Access Compliance Report

Public Rights-of-Way

(Curb Ramps)

Intersection ID: 3919	Main Street: MOUNTAIN_PARK_DR	Cross Street: MT_ISLE_HARBOR_DR	Location: NE
ADA ID: BD96BAF14E99	Ramp Type: Perp	Initial Pass/Fail: Fail	Overall Compliance: No
			Severity Score: 10

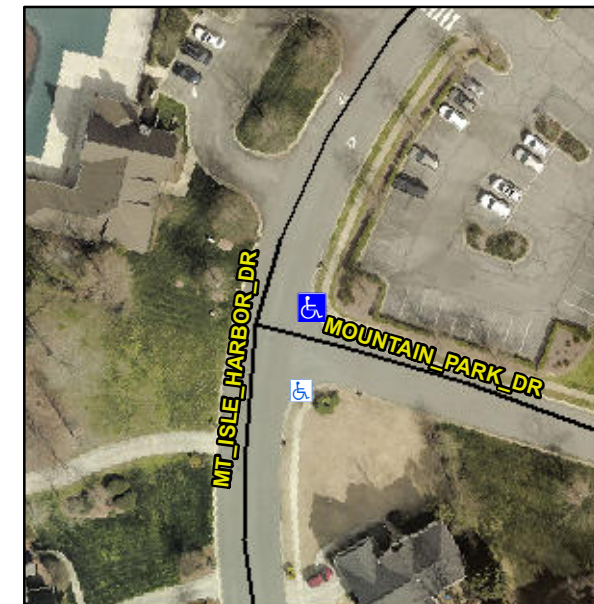
Not Found, R304.5.1, R304.5.3

Compliance	Description	Data	Compliance	Description	Data
N/A	Ramp Length (in)	47.0	Yes	Ramp Slope (%)	7.8
No	Ramp Width (in)	47.5	No	Ramp XSlope (%)	2.9
N/A	Flare Type LT	N/A	N/A	Flare Type RT	N/A
N/A	Flare Slope LT (%)	N/A	N/A	Flare Slope RT (%)	N/A
N/A	Flare Traversable LT?	N/A	N/A	Flare Traversable RT?	N/A
N/A	Landing Length (in)	N/A	N/A	DWS Provided?	N/A
N/A	Landing Width (in)	N/A	N/A	DWS Contrast?	N/A
N/A	Landing Slope (%)	N/A	N/A	DWS Length (in)	N/A
N/A	Landing X Slope (%)	N/A	N/A	DWS Full Width?	N/A
N/A	Landing Curb? (Y/N)	N/A	N/A	DWS Offset (in)	N/A
N/A	Shared Landing?	N/A			
N/A	Gutter Ponding?	N/A	N/A	Gutter Slope (%)	N/A
N/A	Gutter Lip Ht (in)	N/A	N/A	Gutter X Slope (%)	N/A
N/A	Painted X Walk1?	No	N/A	Painted X Walk2?	N/A
	X Walk 1 Direction	To S		X Walk 2 Direction	N/A
N/A	X Walk 1 Width (in)	N/A	N/A	X Walk 2 Width (in)	N/A
	X Walk 1 Slope (%)	2.6		X Walk 2 Slope (%)	N/A
	X Walk 1 X Slope (%)	1.1		X Walk 2 X Slope (%)	N/A

Remove & Replace Entire Ramp.
